**VILLAGE OF SUGAR GROVE  
BOARD REPORT**

**TO:** VILLAGE PRESIDENT & BOARD OF TRUSTEES  
**FROM:** DANIELLE MARION, PLANNING AND ZONING ADMINISTRATOR  
**SUBJECT:** ORDINANCE: WATERFORD PLACE PUD AMENDMENT, LOT 27 (391 CAPITOL DRIVE)  
**AGENDA:** MAY 7, 2024 VILLAGE BOARD MEETING  
**DATE:** MAY 1, 2024

## **PC24-01**

TO: Village President and Board of Trustees  
FROM: Planning Commission  
DATE: Meeting of February 21, 2024  
PETITION: 24-001 Waterford Place Lot 27 PUD Amendment  
(391 Capitol Drive)

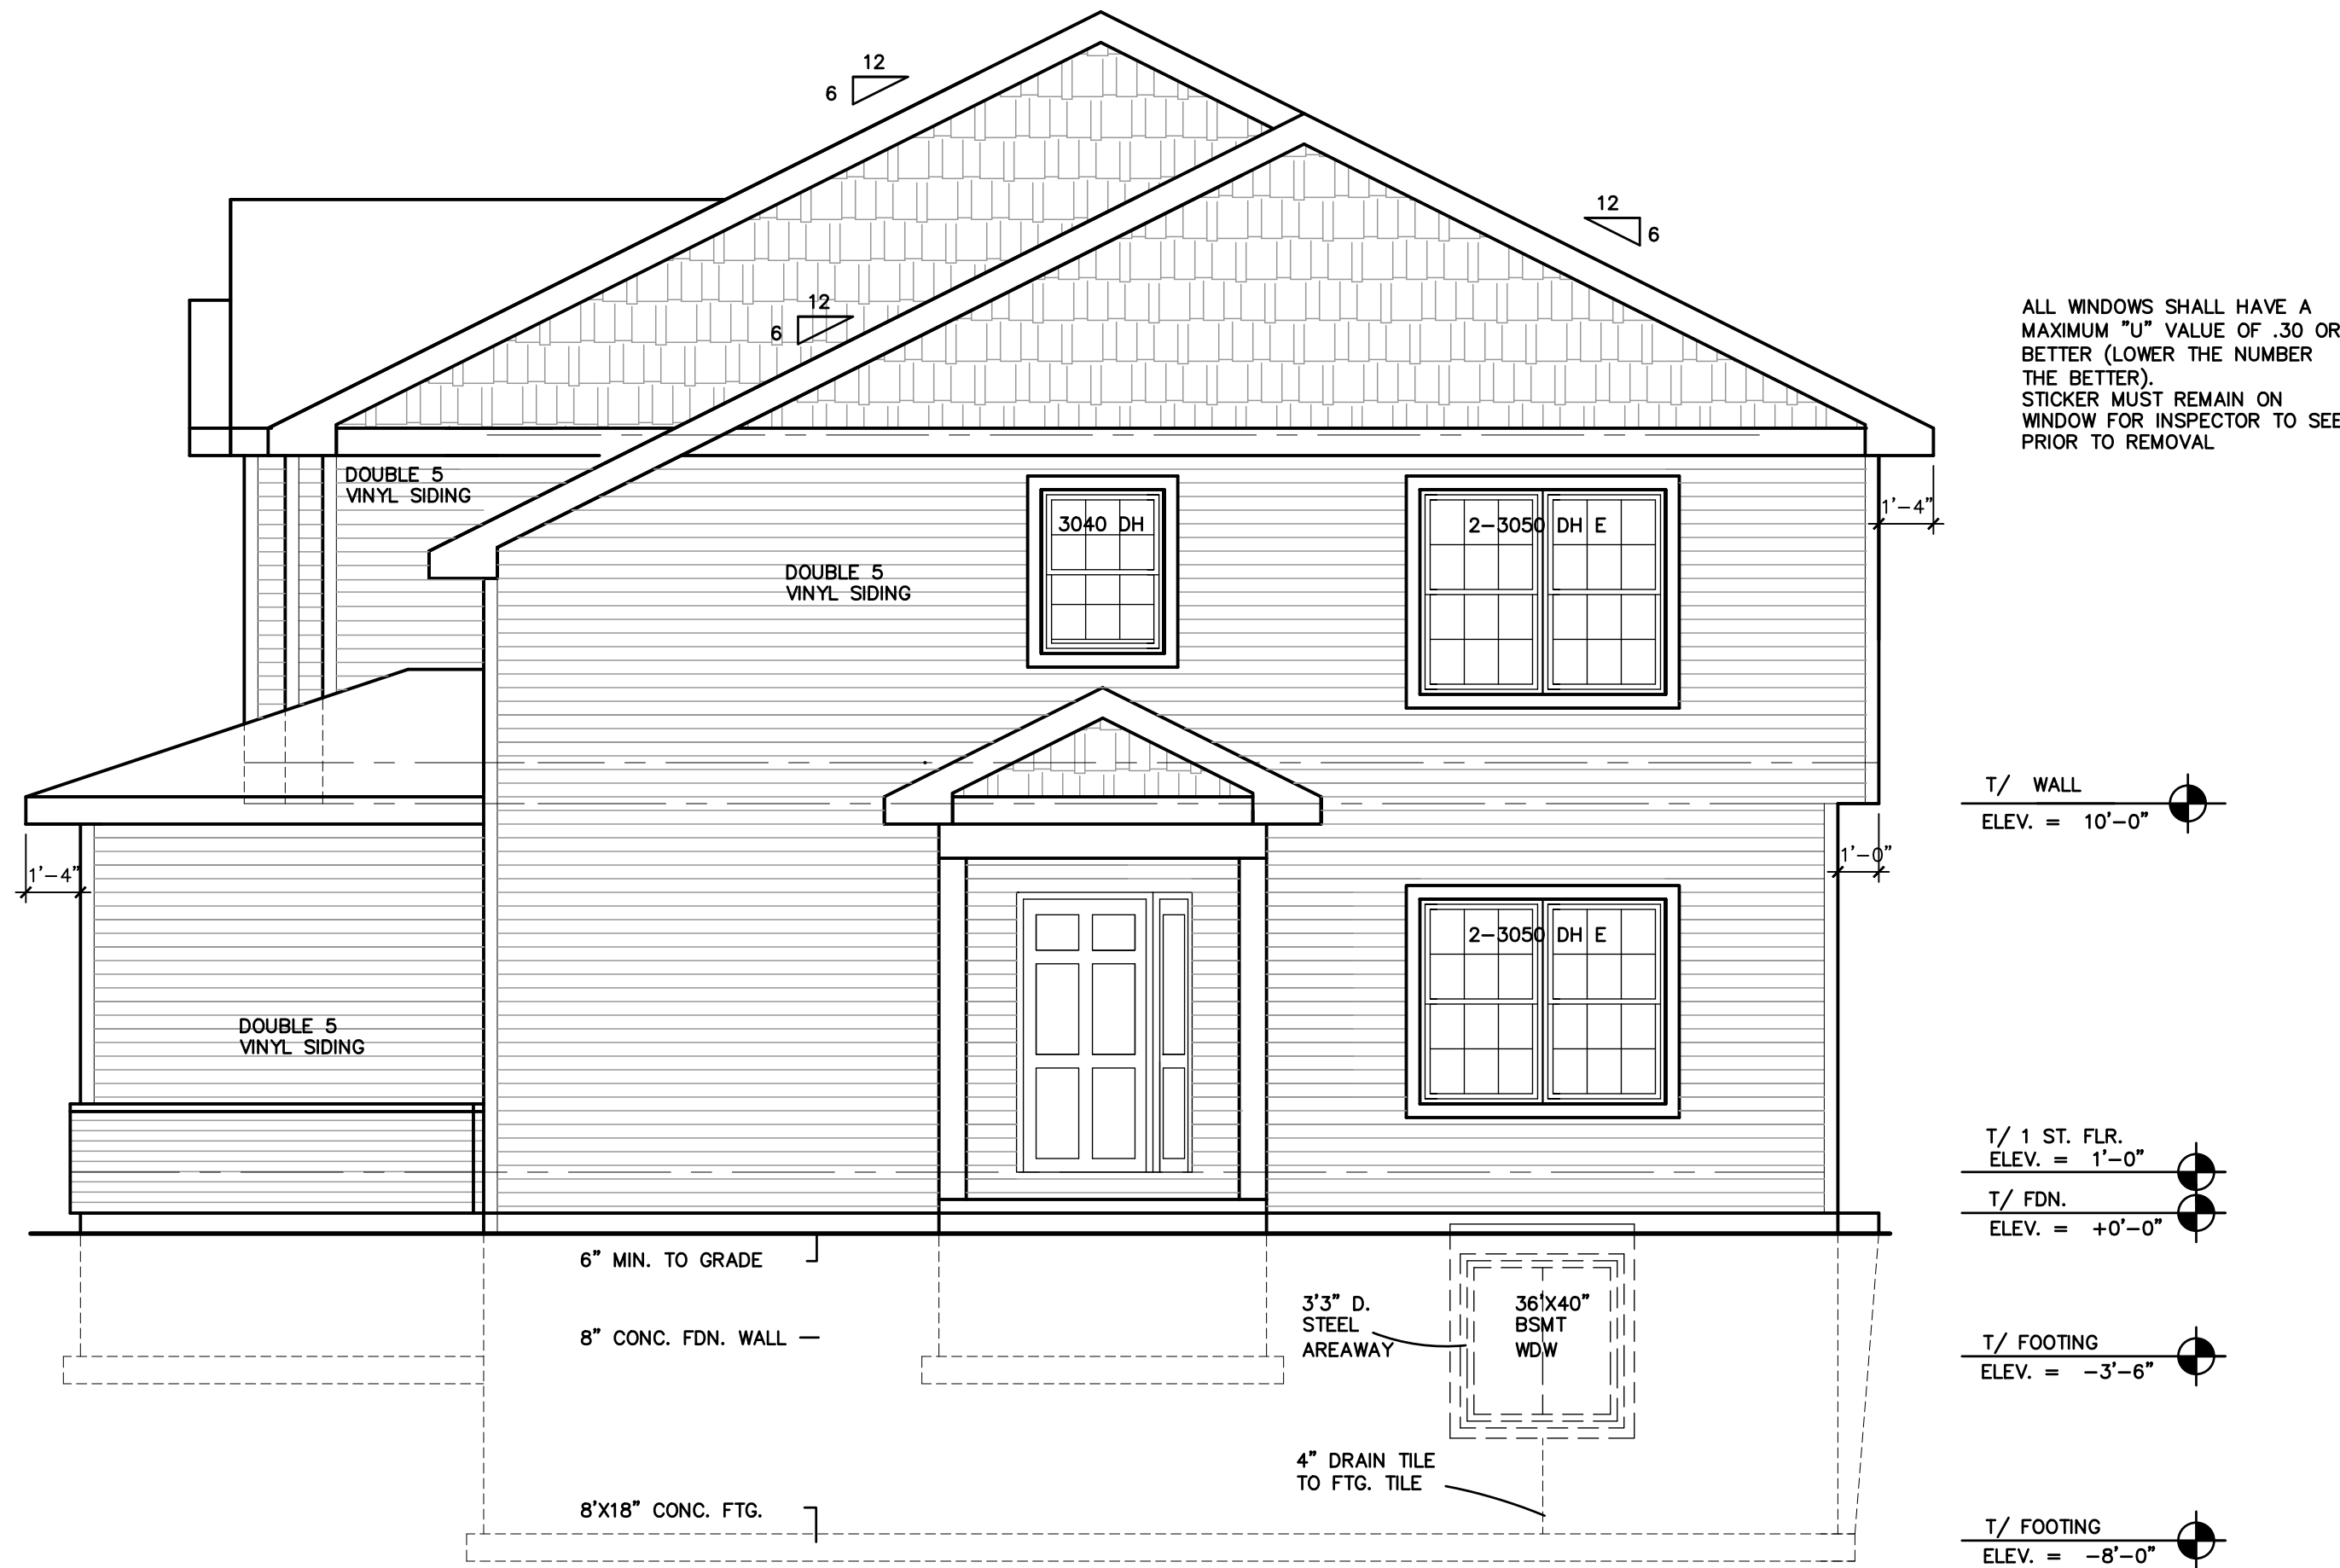
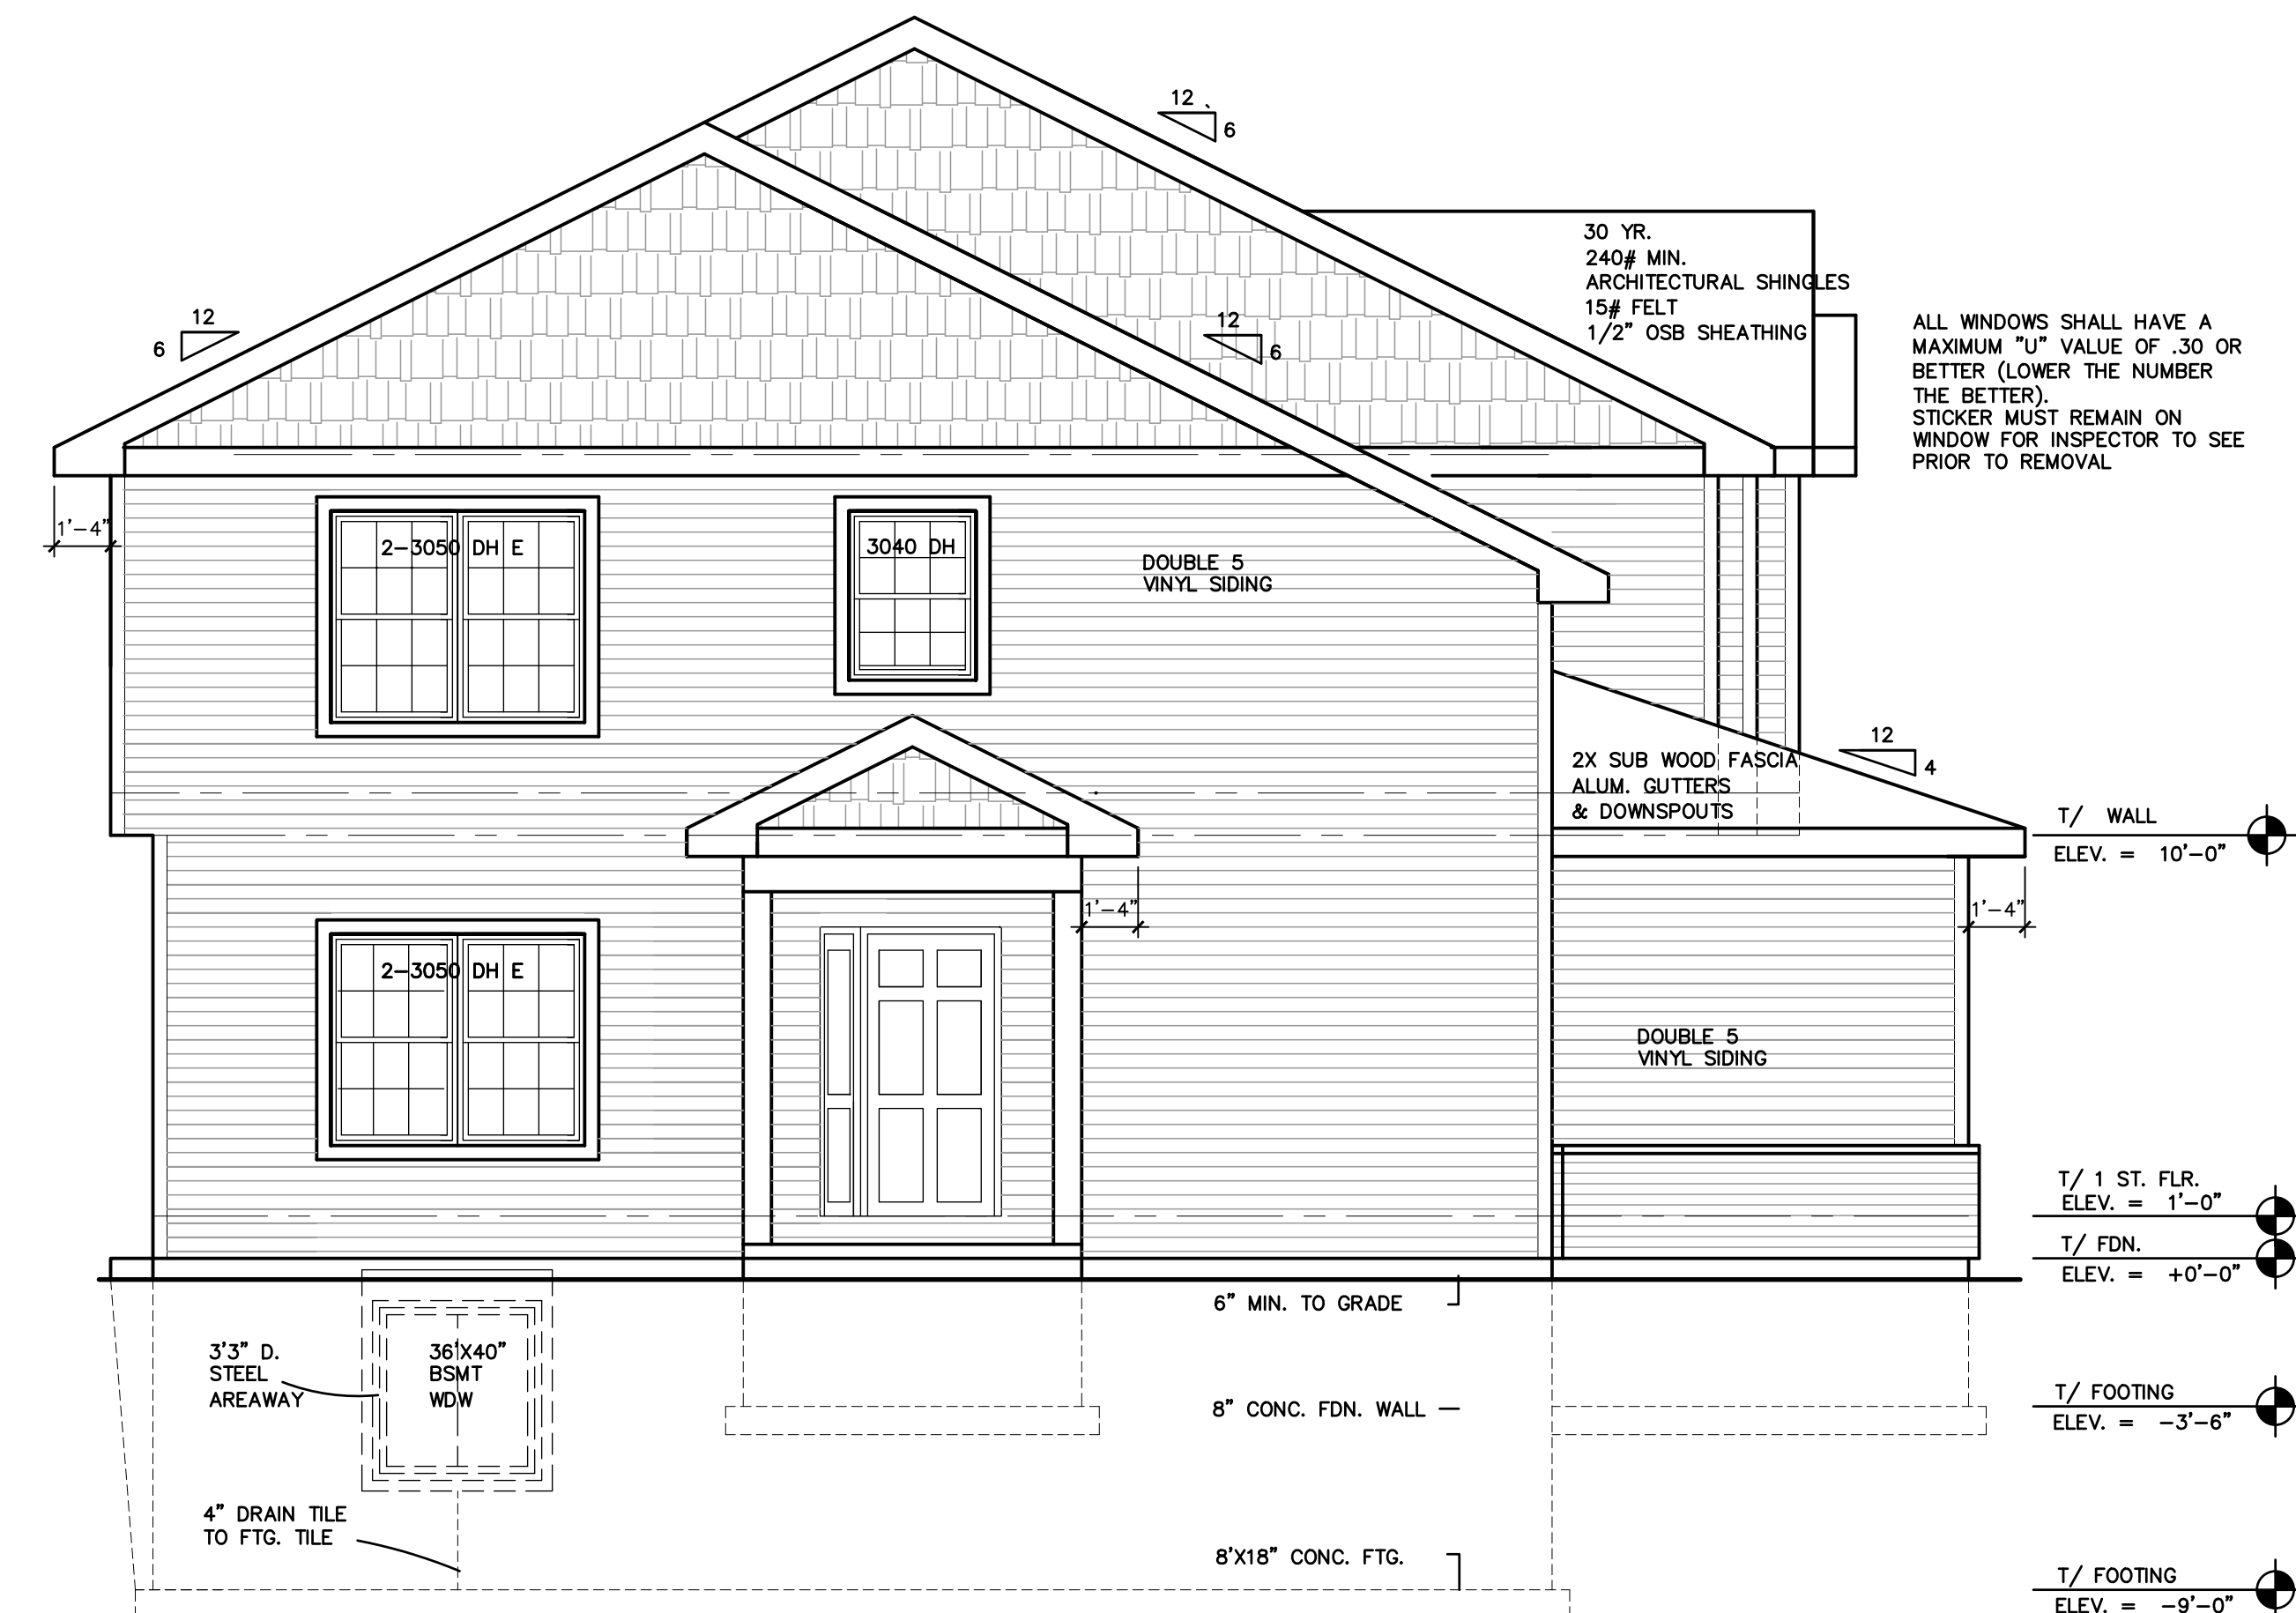
The Board requested that the applicant add brick along the entire bottom portion of the structure as well as wrapping the garages with brick. The applicant has provided revised elevation drawings that show brick being run down part of the side. The applicant has not agreed to wrap the garages as suggested.
